[Docket No. 2003–SW–10–AD]

Airworthiness Directives; Eurocopter France Model AS355E, F, F1, F2, and N Helicopters

ACTION: Notice of proposed rulemaking (NPRM).

Figure 1

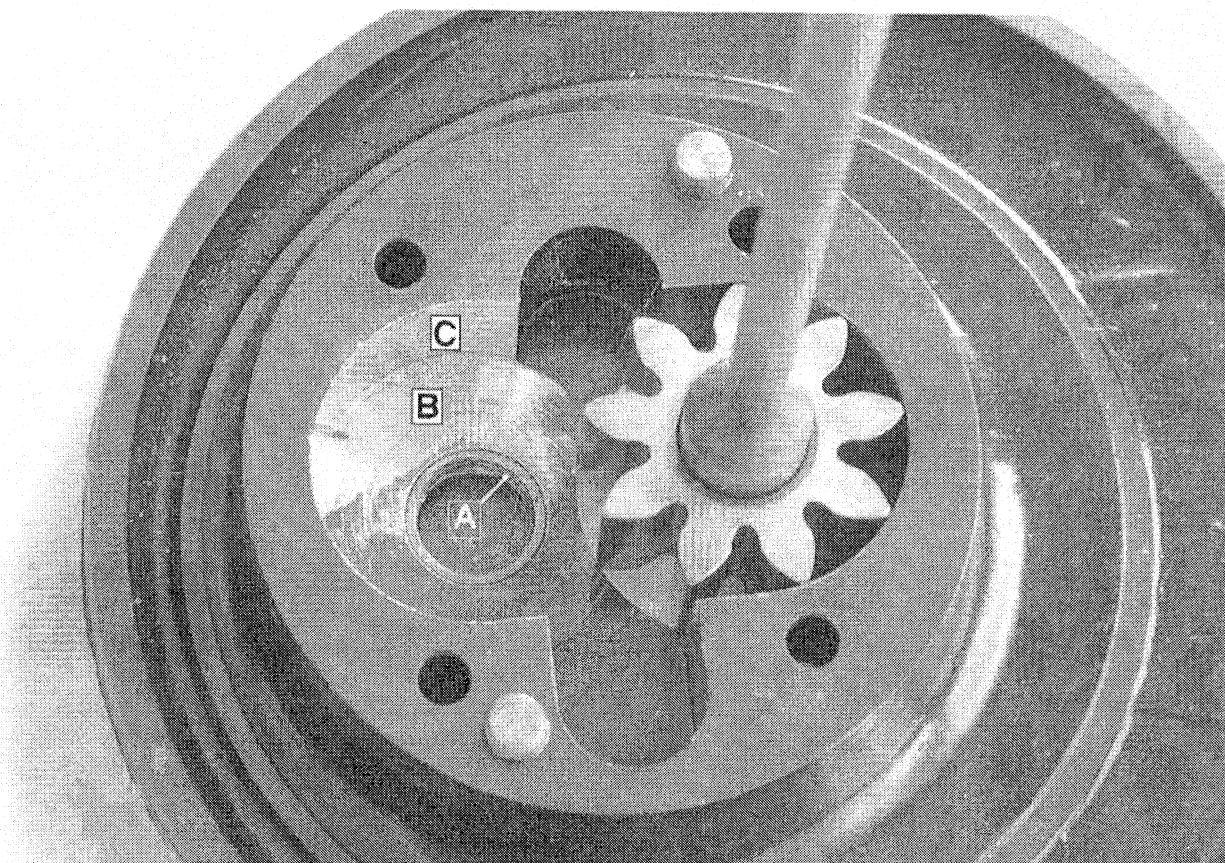
(d) While inspecting the pump, if you find any of the following, replace the MGB and the pump with an airworthy MGB and pump before further flight:

- (1) Crank pin play,
- (2) Out of round bronze bushing (A of Figure 1),
- (3) Offset of the driven gear pinion,
- (4) Metal chips, or
- (5) Wear (C of Figure 1).

Note 2: If wear is present in the B area only as depicted in Figure 1, replacing the MGB and the pump is not required.
